# Three lines of thought about Lower Shaker Lake dam

- 1) Downsizing the NEORSD design would meet local needs
- 2) Understanding the dam failure hazards and working towards a non-Class-I project
- 3) The lake and the 15 minute city

Ben Monreal  
Shaker Heights  
Professor of Physics, CWRU

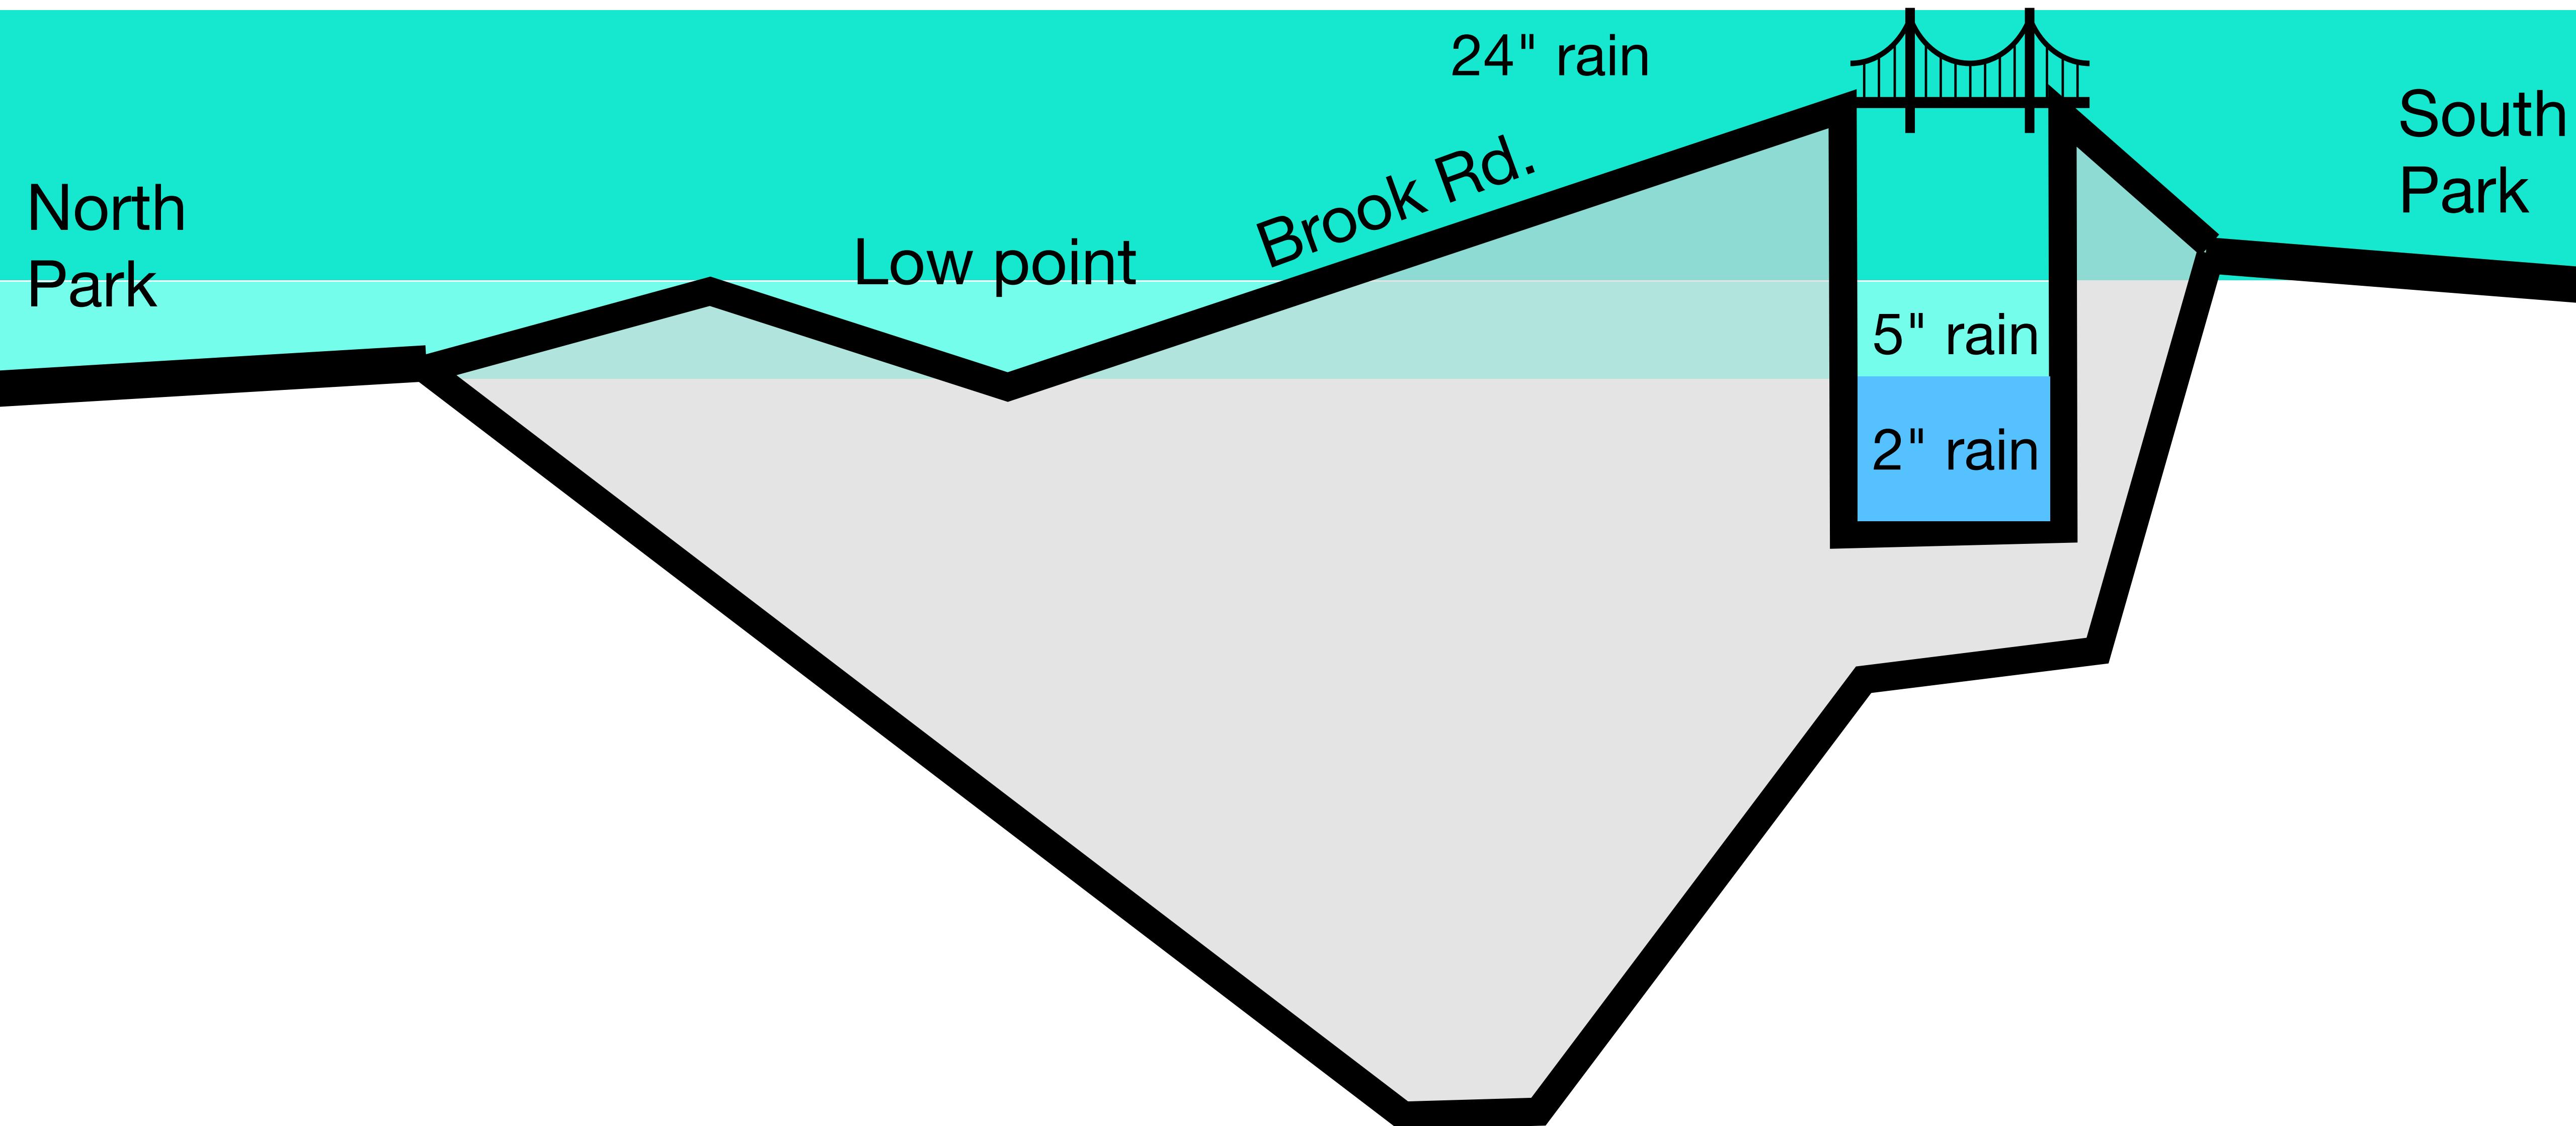
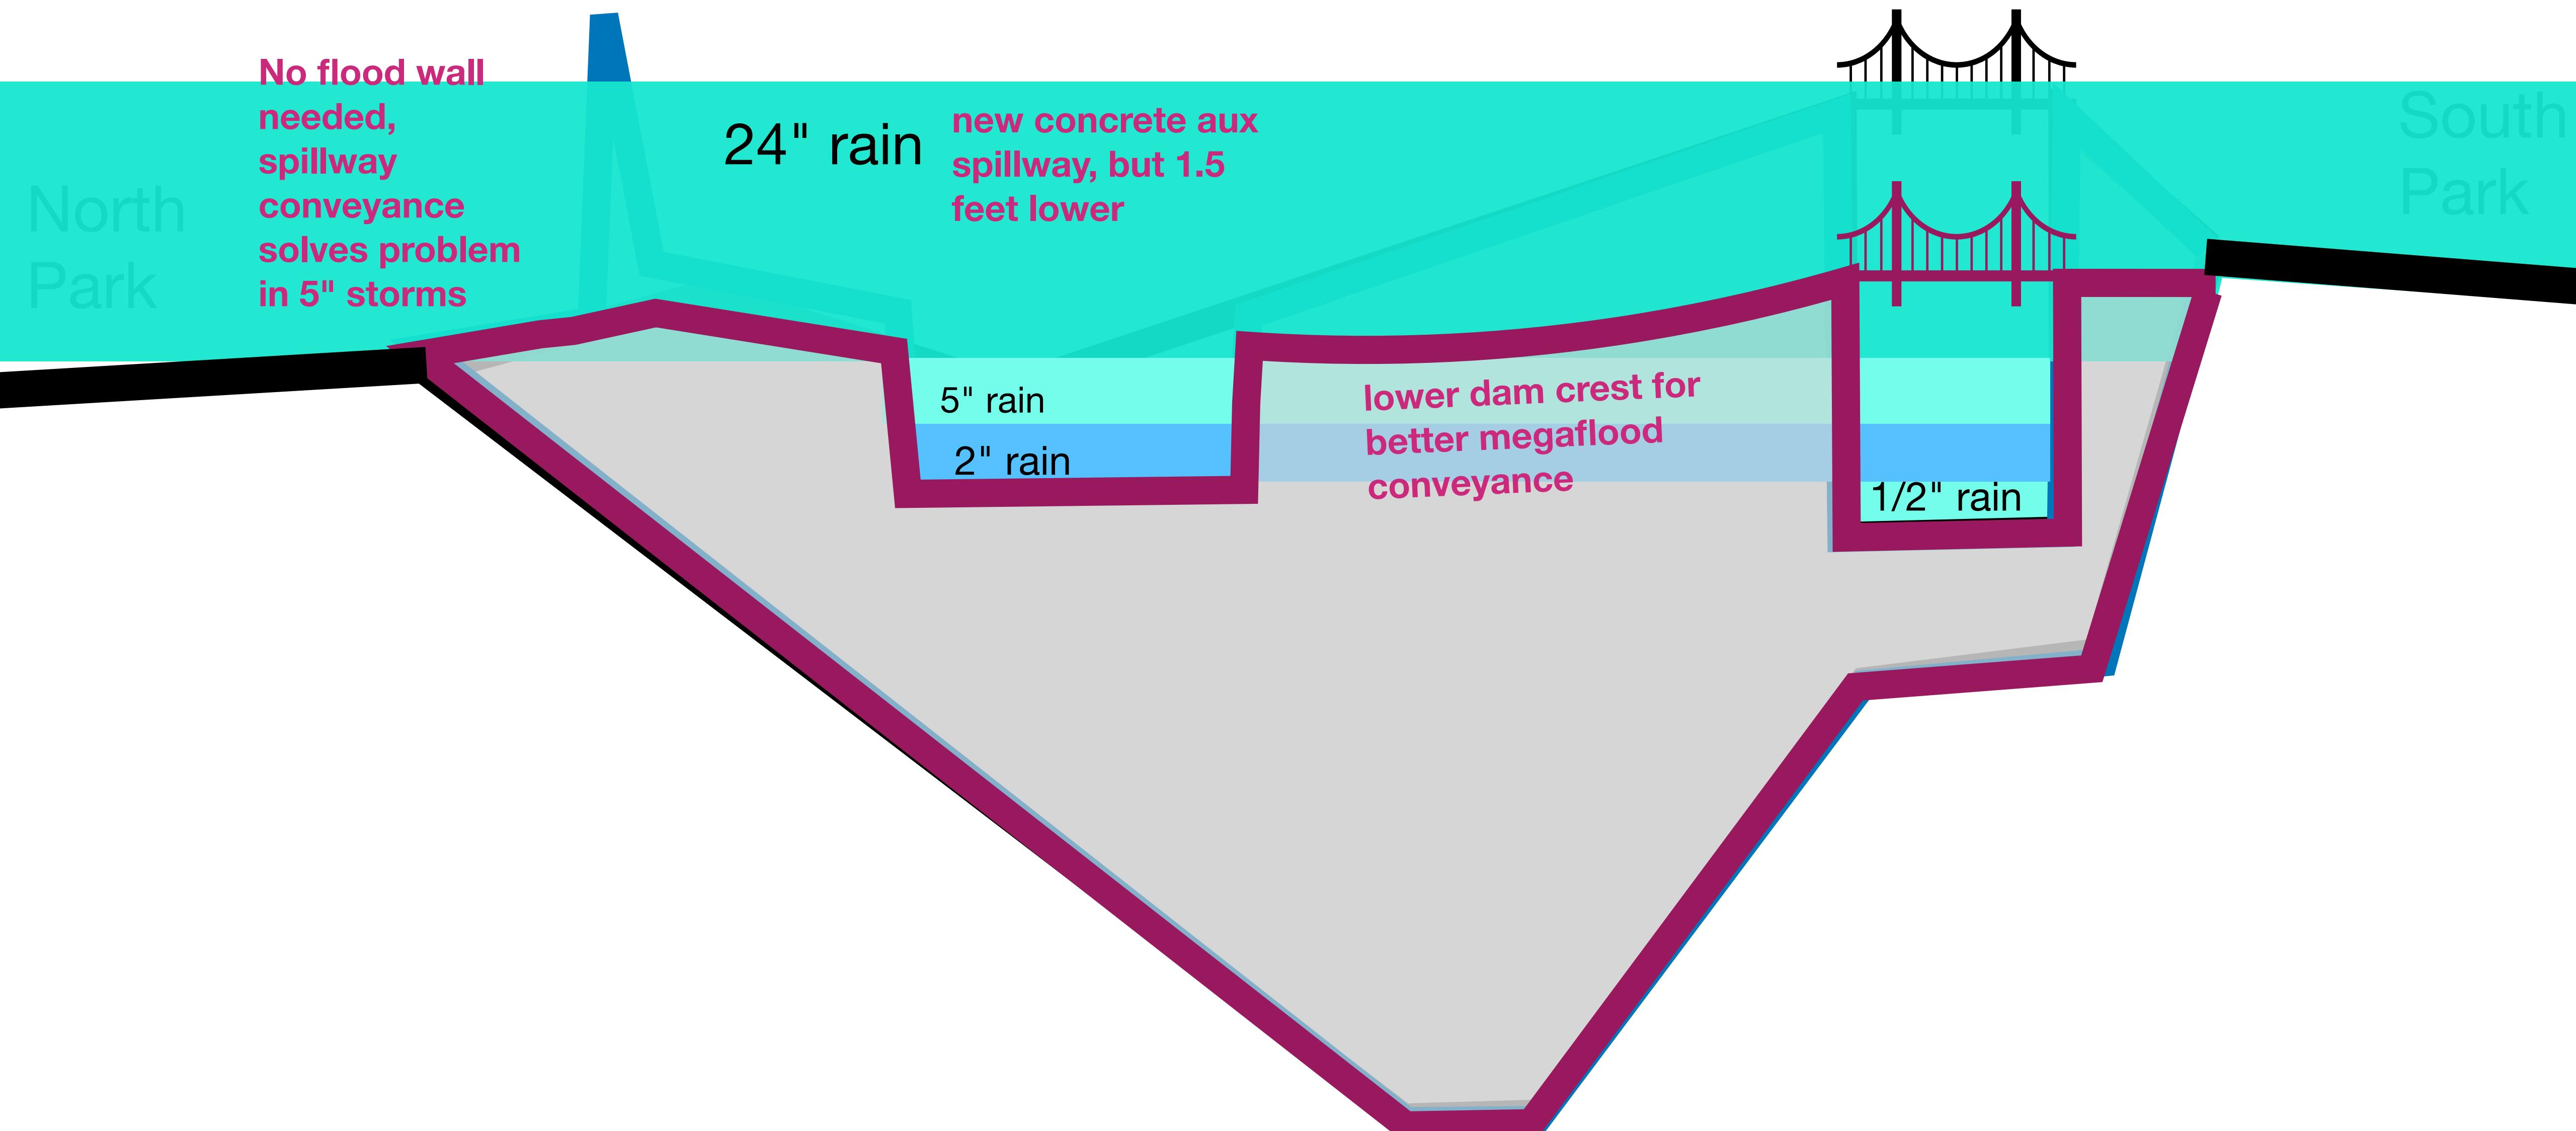
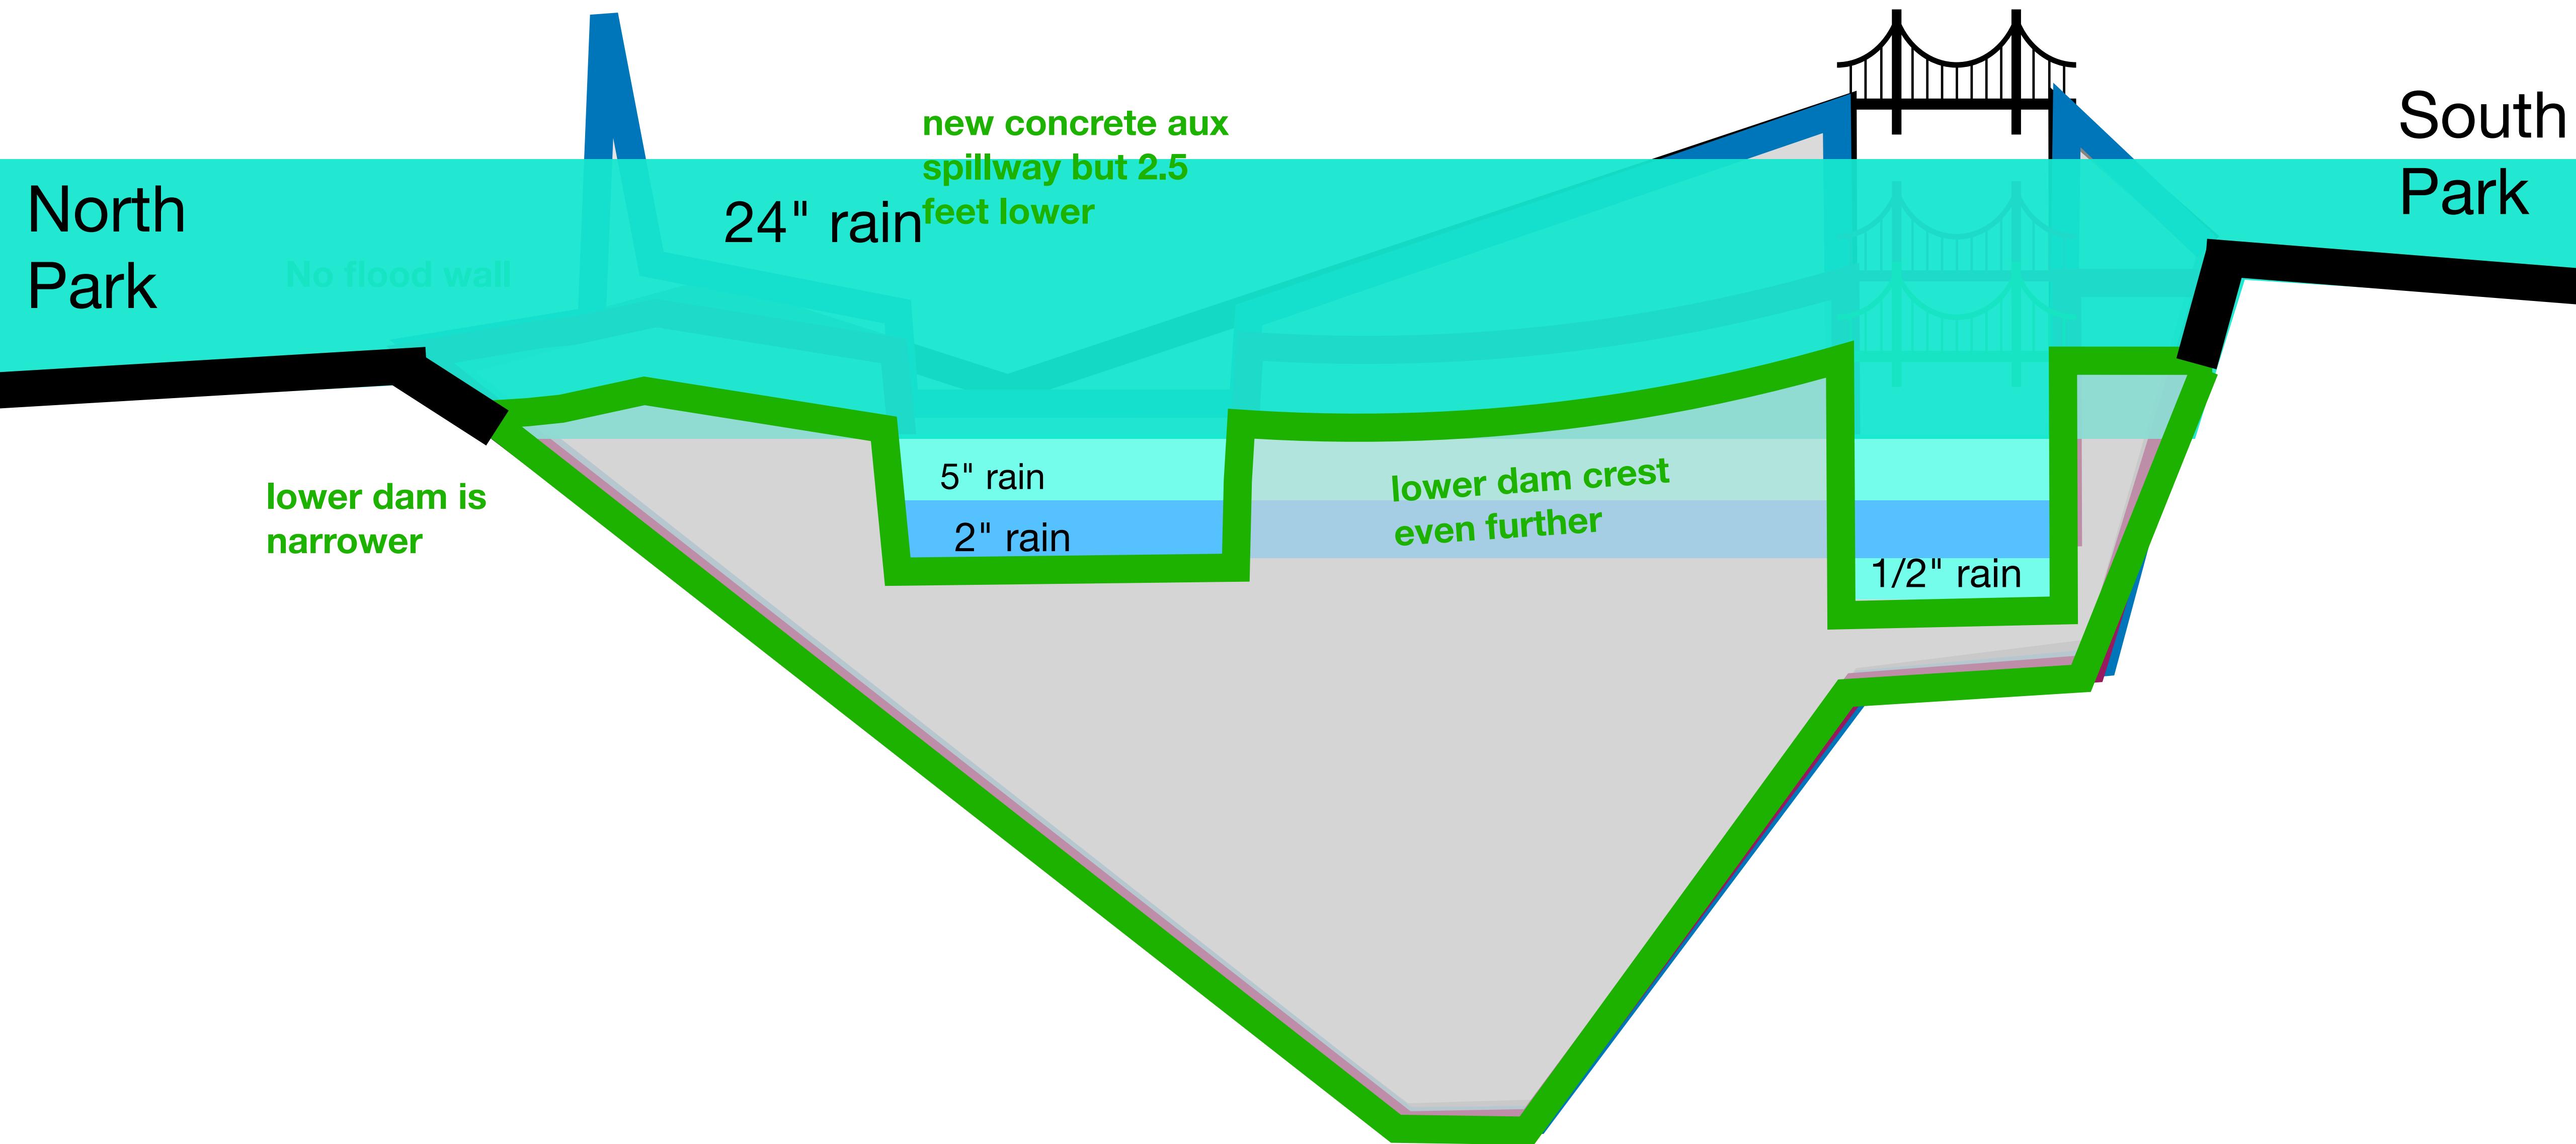
6' high  
floodwall

new concrete  
spillway at same  
height as previous  
low point
